Technical Review - Also known as Feasibility Analysis, is basically a review of the print and other applicable standards by the factory and their confirmation if or not they their current infrastructure and processes are able to meet all those requirements. Typically they will come to this meeting with a balloon print and their Yes/No for each dimension+ allowed tolerance called out on the print. Furthermore, this is a great time for them to ask questions about Porosity acceptance standards, weld requirements/ paint / plating/ surface finish requirements, packaging requirements/ testing requirements etc. The meeting also serves as an opportunity for Demco to share any past experiences/ lessons learned from the past that might make the product development phases easier for the factory .

DRAWING NO. 13765		REV D	
DESCRIPTION SQUARE CLAMP STEM		DATE 06/03/10	
DRAWN BY BVPD		DATE 04/14/25	
APPROV. BY NM		WEIGHT 0.11	
VOLUME 0.4		SCALE 1:1	
SHEET 1 OF 1

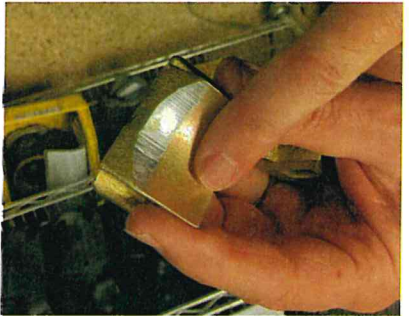
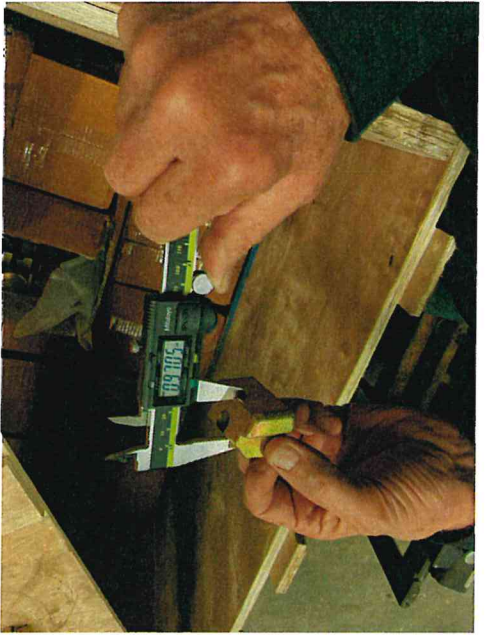
What is the Radi 4 Places

* What is the surface finish Requirement

250 or 280

Please help provide additional technical details for the feasibility review.

1. Forging Process

- * Please confirm whether this part will be produced by closed die forging.
- * Please share forging process pictures and similar forged parts if available.
- * Please confirm expected forging tolerance capability.

2. Material & Heat Treatment

- * Please confirm exact material grade proposed.
- * Please explain how hardness RC 22-32 will be controlled and verified.
- * Please confirm whether heat treatment is done in-house or outsourced.
- * Please share pictures of hardness testing equipment.

3. Machining

- * Please confirm which dimensions/features will be machined after forging.
- * Please share machining process flow.
- * Please share pictures of CNC/VMC machines planned for this part.
- * Please confirm how center hole position and consistency will be controlled.

4. Plating & Salt Spray

- * Please confirm whether yellow zinc plating supplier can meet 120-hour salt spray requirement.
- * Please share any available salt spray test reports for similar parts.
- * Please explain how plating quality will be controlled.

5. Inspection & Quality

- * Please prepare balloon drawing for the print.
- * Please identify critical dimensions and inspection method.
- * Please share pictures of inspection equipment and gauges.
- * Please confirm if dimensional reports will be provided with samples.

6. Production Control

- * Please advise any dimensions or areas you believe may create manufacturing risk during mass production.
- * Please confirm estimated rejection risk areas if any.

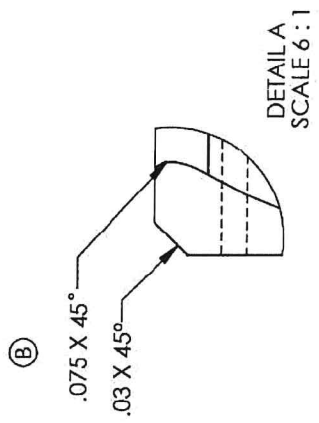
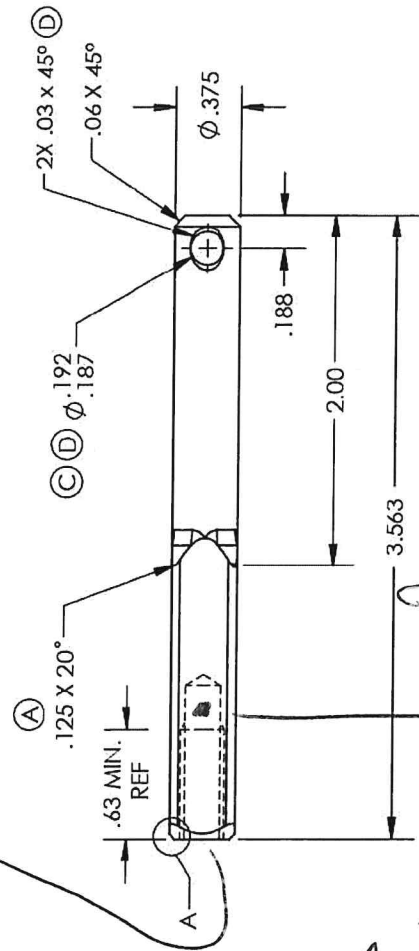
Can beta vapor lock during cleaning prior to zinc plating

MACHINE OFF CORNERS what is the max for Break Edges

For the 13765 stem the print calls for [CR] Cold Roll / Cold drawn

So, I would like 1045 or equal yield strength .

So, in the US we have 1045 or 1117 or 1215 which are all equal or better than 1045. The 1117 & 1215 have better machinability but might not be available in some places.

You also have to make sure and knock the corners off the square section so that across corners is no more than .489

They are silver/ clear zinc plated . From pass experience you need to be careful that the acid wash does not stay in the threaded hole and cause rust on the threads . We have had this issue before and they get rejected
